TO: Mercedes-Benz Dealer Principals, General Managers, Sales Managers, Service Managers, Parts Managers	FROM: Gregory Gunther, Senior Manager, Vehicle Compliance and Analysis, Engineering Services
RE: <b>Emission Service Campaign Launch Notification</b> <b>Apply an additional VECI Label</b> <b>MY22-24 EQE, EQS (294, 295, 296 and 297 platforms)</b>	DATE: February 27, 2025

Campaign No. 2025010004, February 2025

SUBJECT: **Model EQE and EQS (294, 295, 296 & 297 platform)**  
**Model Year 2022 – 2024**

### **Apply Additional VECI Label**

**Figure 1:** New position of VECI label

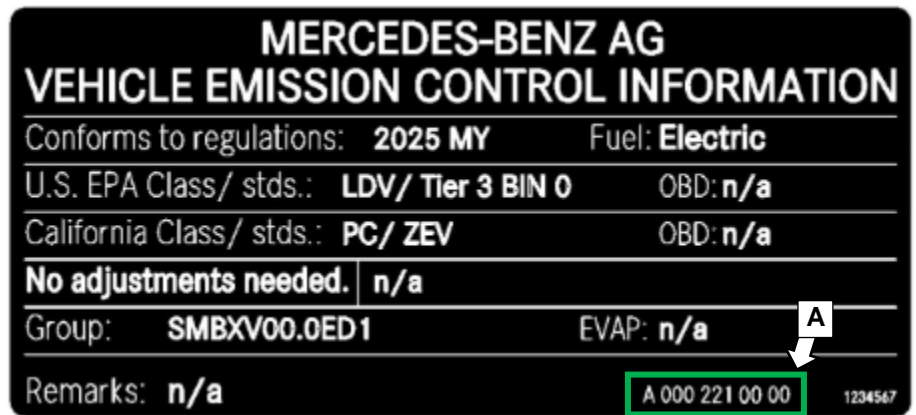
Mercedes-Benz AG, the manufacturer of Mercedes-Benz vehicles, has determined that on certain MY 2022-2024 EQE and EQS (294, 295, 296 & 297 platform) vehicles, the Vehicle Emission Control Information (VECI) label in the engine compartment may not be readily visible to customers, since the Operator's Manual directs that only workshop personnel are permitted to open the hood. An authorized Mercedes-Benz dealer will attach an additional VECI label on the driver's door of affected vehicles so that the label is readily visible to the customer.

1. Open driver's door.
2. Clean the bonding point on driver's door (**Figure 1, 1**) with a suitable cleaning agent before attaching the new exhaust gas cleaning information label (**Figure 2, 1**).

3. Check that the new label part number (**Figure 2, A**) matches the part number in the table above for the respective Baumuster and Model Year of the vehicle.
4. Attach the new VECI label (**Figure 2**) in the new position on the driver's door (**Figure 1, 1**).
